Access Compliance Report

Public Rights-of-Way

(Curb Ramps)

Intersection ID: 29551	Main Street: WHITEHALL_PARK_DR	Cross Street: ARCO_CORPORATE_DR	Location: SE
ADA ID: 5A00DB1CCF63	Ramp Type: PerpDiag	Initial Pass/Fail: Fail	Overall Compliance: No
Severity Score: 37.5			
Codes/Mitigation Info/Possible Solution		Field Measurements/Component Compliance

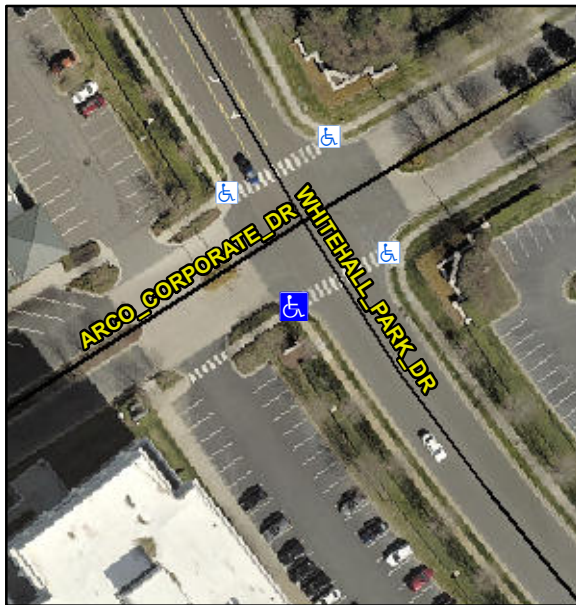
R304.2.2, R304.5.3

Compliance	Description	Data	Compliance	Description	Data
N/A	Ramp Length (in)	83.0	No	Ramp Slope (%)	11.6
Yes	Ramp Width (in)	48.0	No	Ramp XSlope (%)	7.6
N/A	Flare Type LT	N/A	N/A	Flare Type RT	N/A
N/A	Flare Slope LT (%)	N/A	N/A	Flare Slope RT (%)	N/A
N/A	Flare Traversable LT?	N/A	N/A	Flare Traversable RT?	N/A
N/A	Landing Length (in)	N/A	N/A	DWS Provided?	N/A
N/A	Landing Width (in)	N/A	N/A	DWS Contrast?	N/A
N/A	Landing Slope (%)	N/A	N/A	DWS Length (in)	N/A
N/A	Landing X Slope (%)	N/A	N/A	DWS Full Width?	N/A
N/A	Landing Curb? (Y/N)	N/A	N/A	DWS Offset (in)	N/A
N/A	Shared Landing?	N/A			
N/A	Gutter Ponding?	N/A	N/A	Gutter Slope (%)	N/A
N/A	Gutter Lip Ht (in)	N/A	N/A	Gutter X Slope (%)	N/A
N/A	Painted X Walk1?	Yes	N/A	Painted X Walk2?	No
	X Walk 1 Direction	To NE		X Walk 2 Direction	To NW
N/A	X Walk 1 Width (in)	96.0	N/A	X Walk 2 Width (in)	N/A
	X Walk 1 Slope (%)	4.5		X Walk 2 Slope (%)	0.3
	X Walk 1 X Slope (%)	0.5		X Walk 2 X Slope (%)	3.0

N/A	Ramp inside XWalk1?	Yes	N/A	Ramp inside XWalk2?	N/A
	Road Slope (%)	3.6	N/A	Clear Space?	N/A
	Road X Slope (%)	3.2	N/A	Clear Space to XWalk (in)	N/A
N/A	Any Obstructions?	N/A	N/A	Storm Grate/Utility Hazard?	N/A
	Obstruction Type			Storm Grate/Utility Type	
		N/A			N/A
		Yes		Surface Condition? (G/P)	Good

Remove & Replace Curb Ramp With Two New Directional Ramps or Equivalent.
